Enclosure C  
ULNRC- 941

MARKED TECHNICAL SPECIFICATION PAGES

FIGURE 6.2-2  
UNIT ORGANIZATION

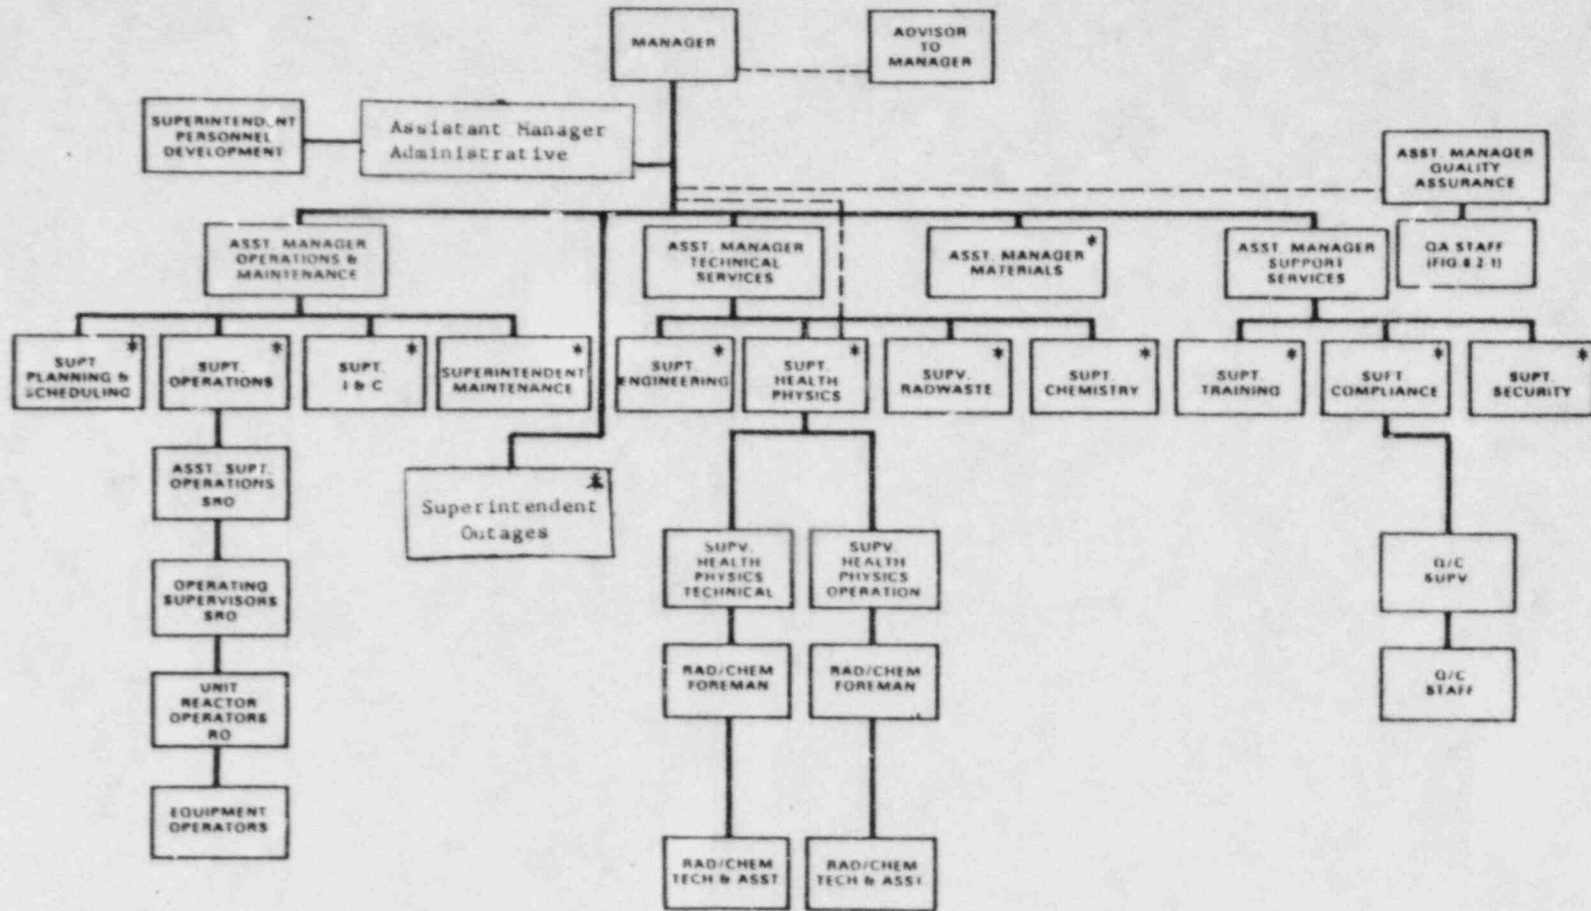
Chairman:	Manager, Callaway Plant
Member:	Asst Mgr, Oper and Maintenance
Member:	Asst Mgr, Tech Services
Member:	Asst Mgr, Support Services
Member:	Supt, Health Physics
Member:	Supv Eng, Quality Assurance
*Member:	Adv to Mgr, Callaway Plant
Member:	<i>Asst Mgr, Administrative</i>

\*This member may be removed when this position is abolished.
